## 2.4 Core Cooling Systems

The information in this section of the reference ABWR DCD, including all subsections, tables, and figures, is incorporated by reference with the following departures.

Figure 2.4.1a Residual Heat Removal System (RHR-A)

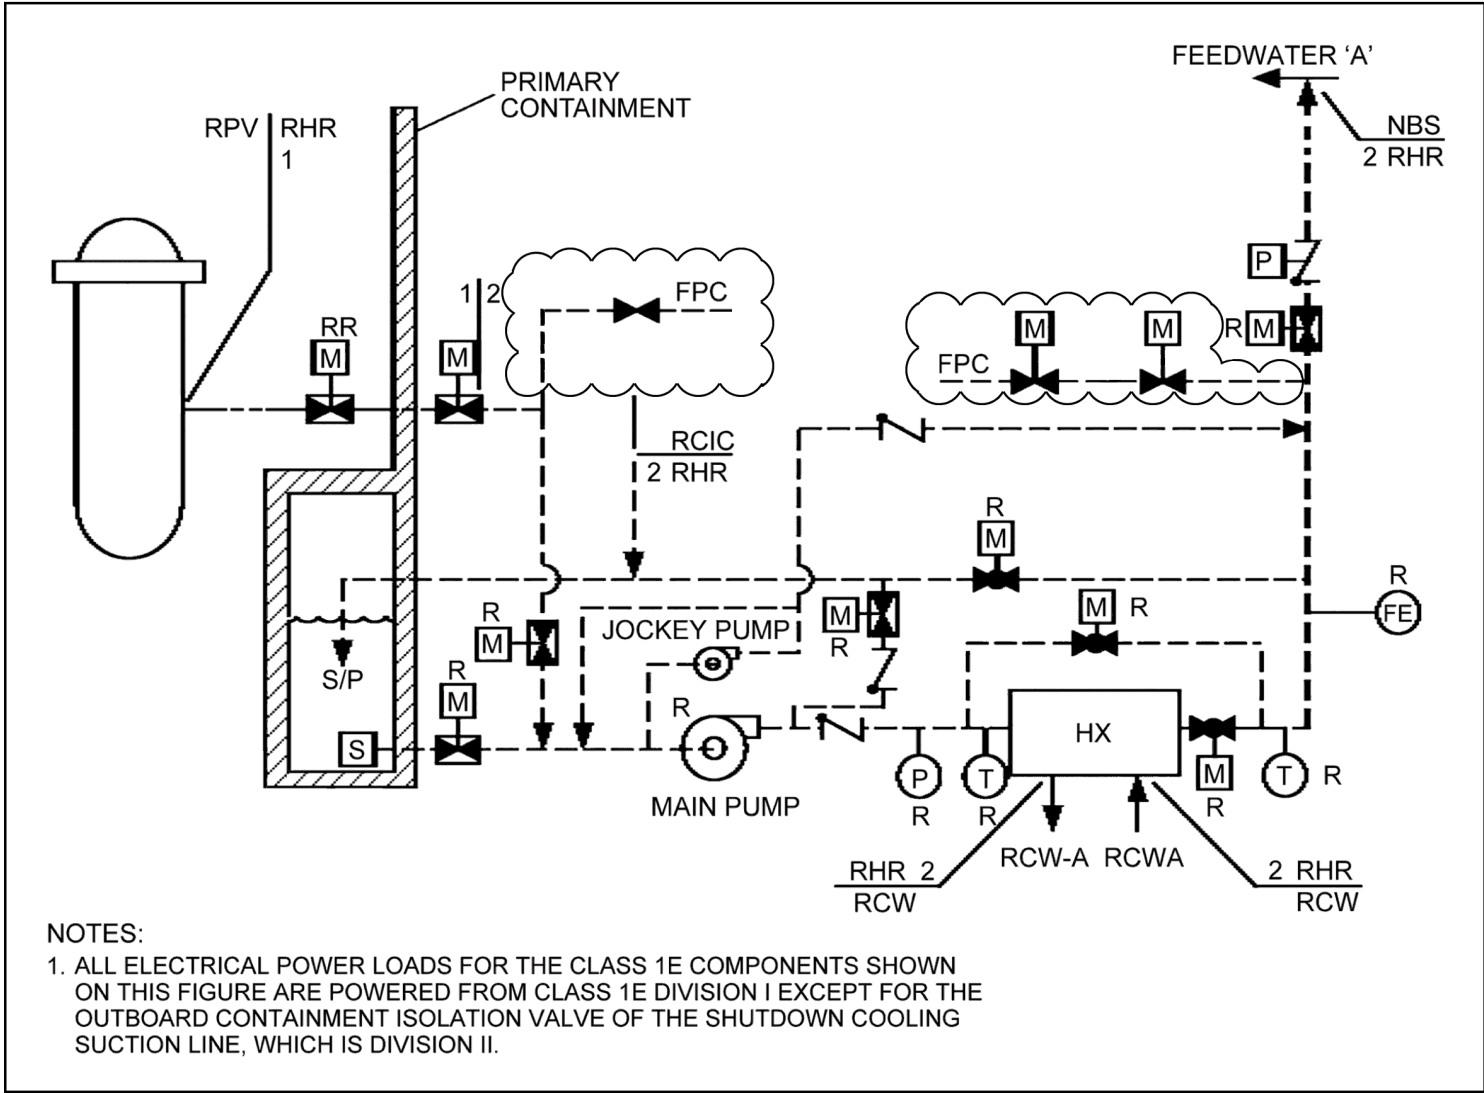
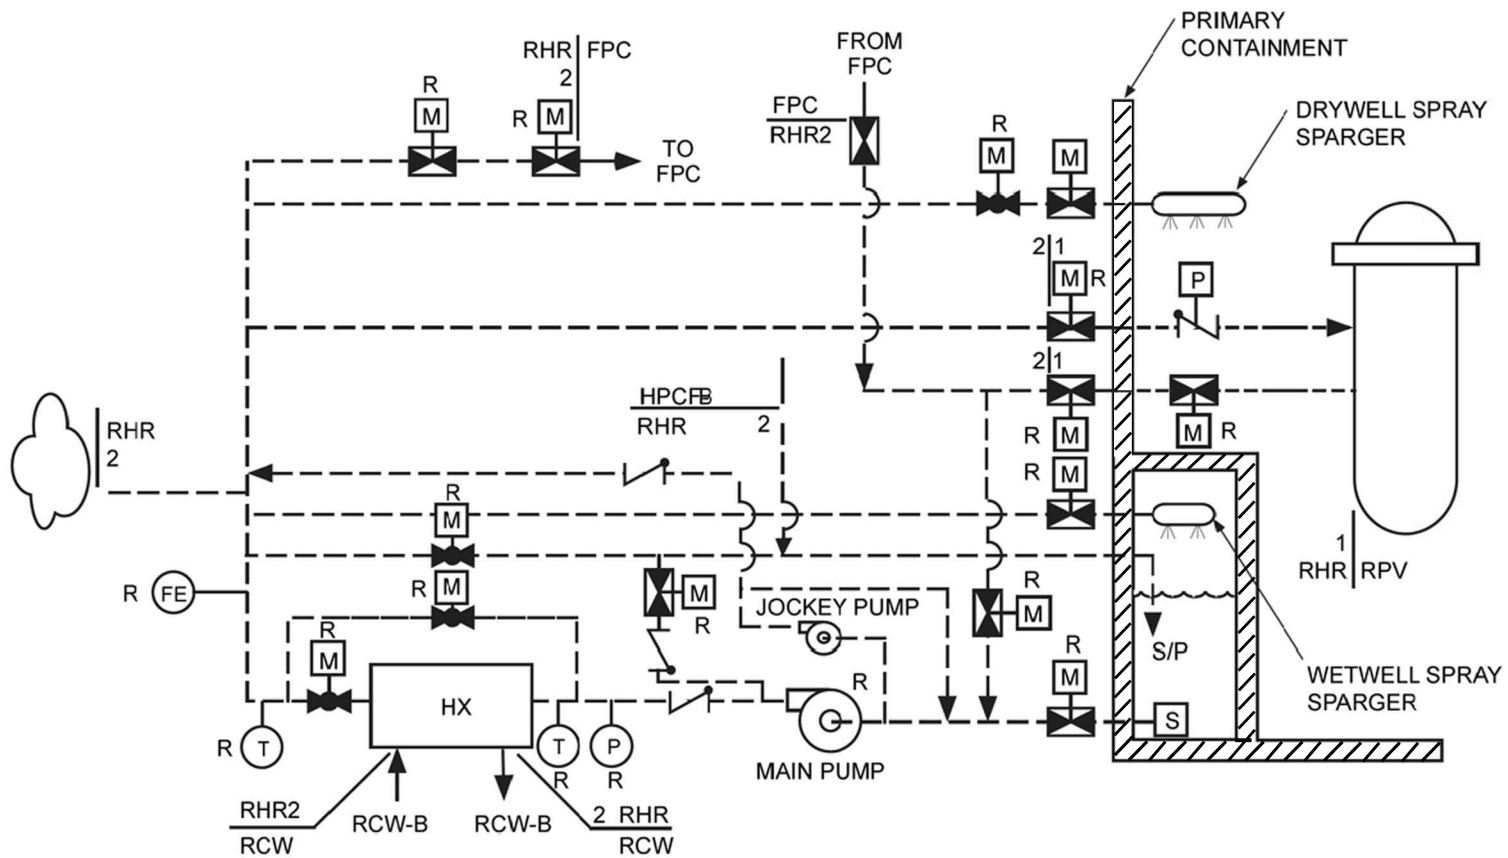
STD DEP T1 2.4-1 (Figure 2.4.1a, Table 2.4.1)

*The piping and components outside the shutdown cooling suction line containment isolation valves and outside the suppression pool containment isolation valves, and upstream of the suction side of the pump with all its branches have a design pressure of 2.82 MPaG for intersystem LOCA (ISLOCA) conditions. Refer to Figures 2.4.1a, 2.4.1b, and 2.4.1c. ~~For RHR A, the upgraded branch lines from the main pump suction include the path to and including the suppression pool suction valve, the path to the shutdown cooling outboard containment isolation valve, and the path to the jockey pump's discharge check valve including the jockey pump's bypass return line. For RHR B and C, the upgraded branch lines include all the paths listed for RHR A plus the path to (and including the valve) the Fuel Pool Cooling System that branches off~~*

~~the shutdown cooling suction line, titled "From FPC."~~ For RHR A and B, the upgraded branch lines from the main pump suction include the path to and including the suppression pool suction valve, the path to the shutdown cooling outboard containment isolation valve, the path to the jockey pump's discharge valve including the jockey pump's bypass line and the path to the (and including the valve) the Fuel Pool Cooling System that branches off the shutdown cooling suction, titled, "From FPC." For RHR-C, the upgraded branch lines include all the paths listed for RHR-A and B plus the pipeline and valves that are part of the AC independent water addition mode that extends from the noncode boundary indicated by "NNS" to the "external connection" outside the "reactor building" and to the Fire Protection System interface indicated by "FP."

Figure 2.4.1c Residual Heat Removal System (RHR-C)

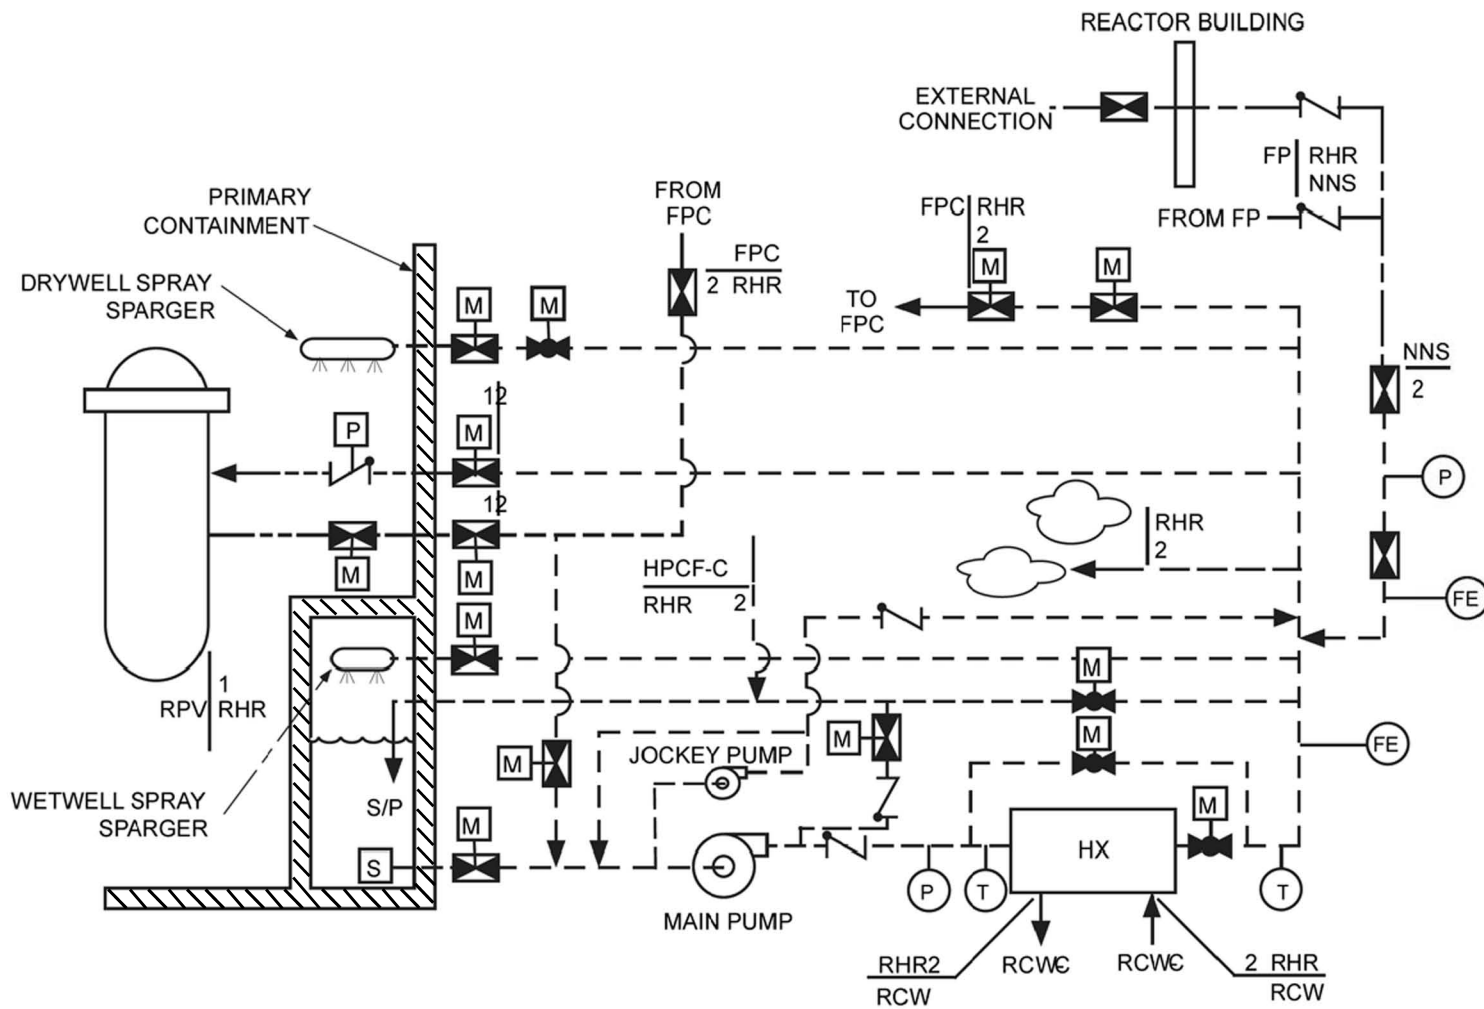
STD DEP T1 2.14-1 (Figure 2.4.1b, Figure 2.4.1c, Figure 2.4.3)

Figure 2.4.2 Leak Detection and Isolation System Interface Diagram

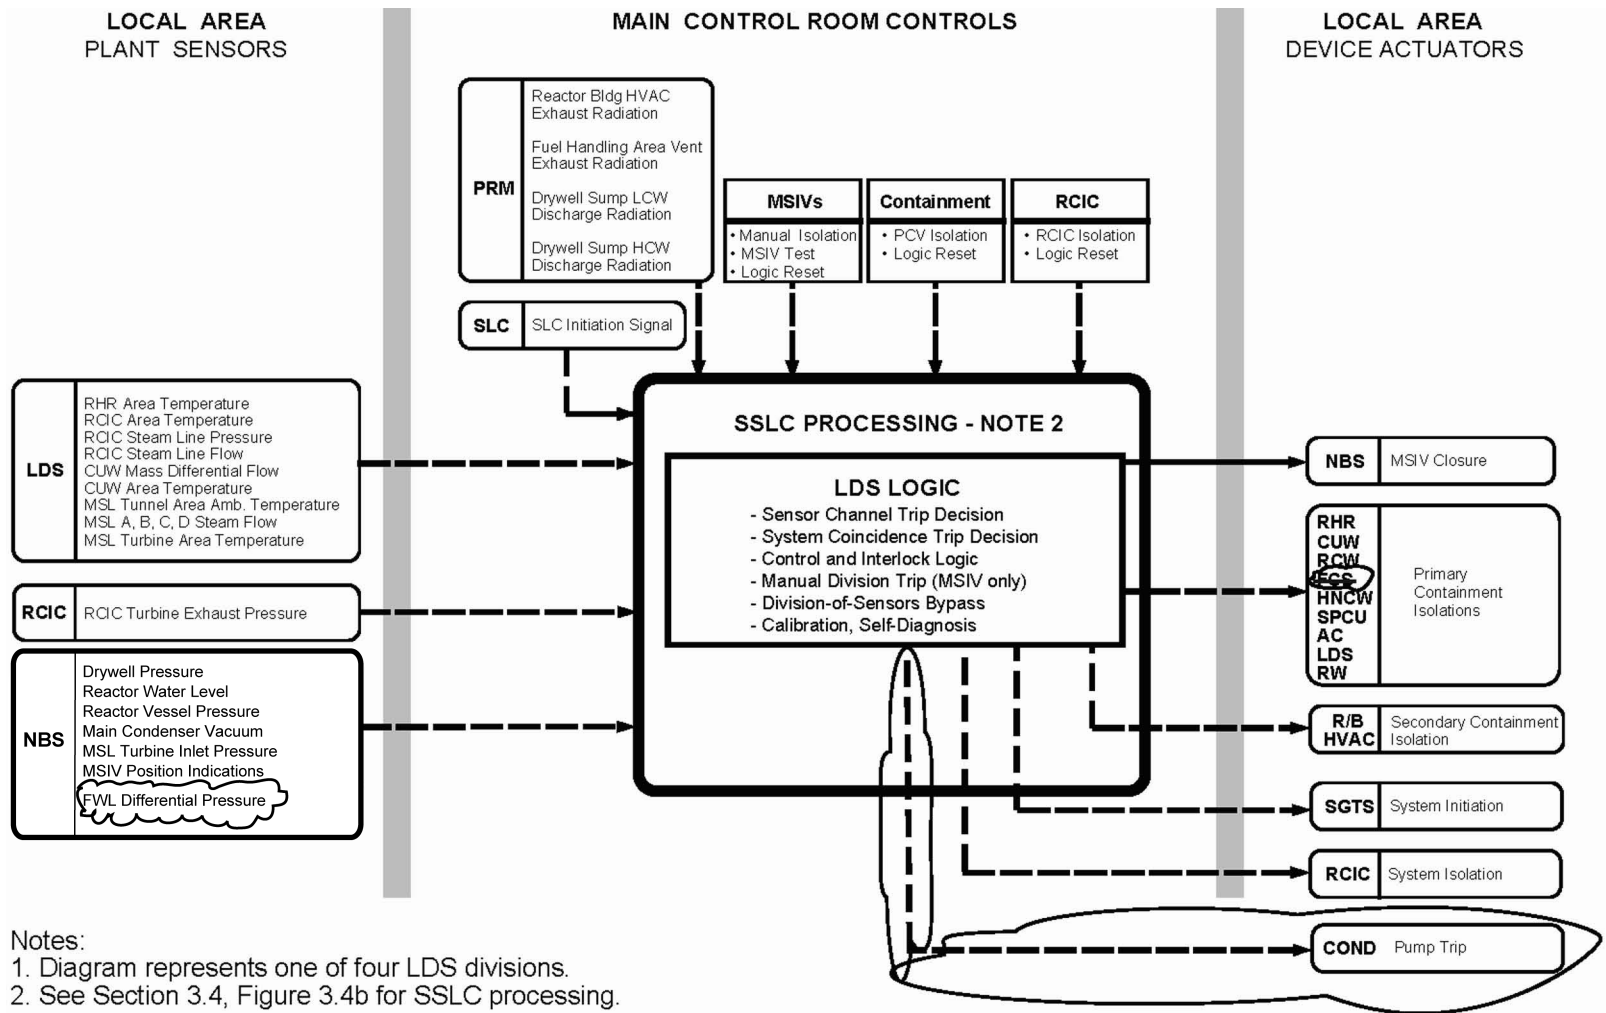
STD DEP T1 2.4-2 (Leak Detection System) Figure 2.4.3

STD DEP T1 2.14-1 (FCS, Figure 2.4.3)

- (9) *Isolation of the Suppression Pool Cleanup (SPCU) System on a signal indicating high drywell pressure or low reactor water level.*
- ~~(10) *Isolation of the Flammability Control System (FCS) on a signal indicating high drywell pressure or low reactor water level.*~~

Figure 2.4.4a Reactor Core Isolation Cooling System

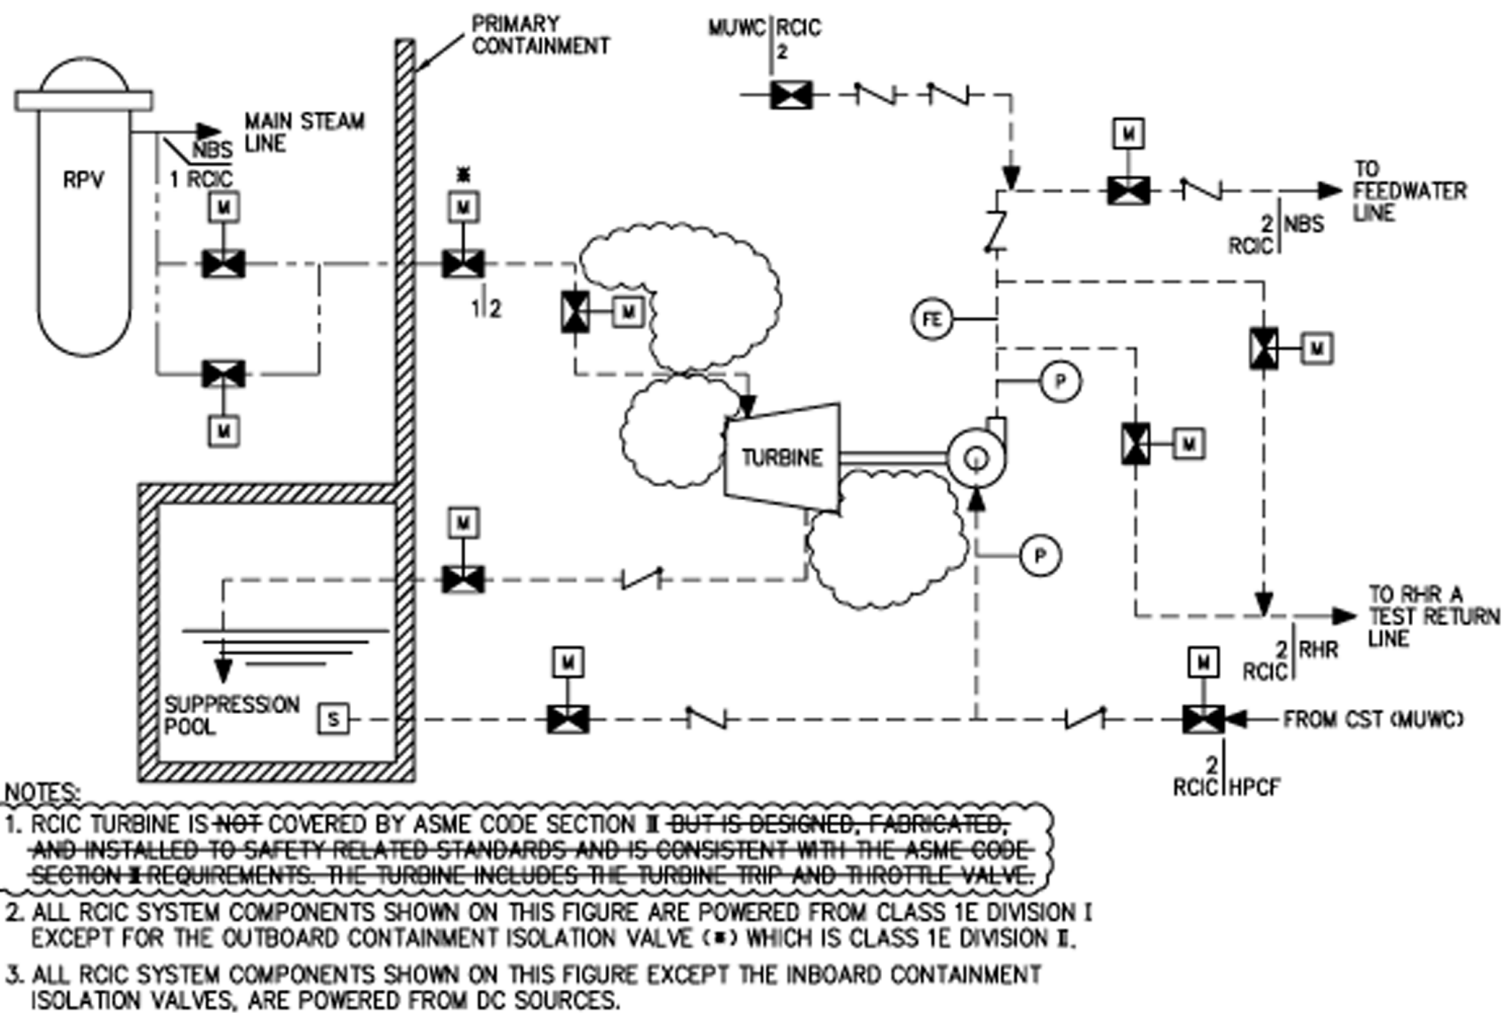
STD DEP T1 2.4-3 (Figure 2.4.4a, Table 2.4.4.)

- (1) Piping and component from the pump suction MOV's up to the pump inlet,*
- ~~(2) Barometric condenser and associated equipment.~~*
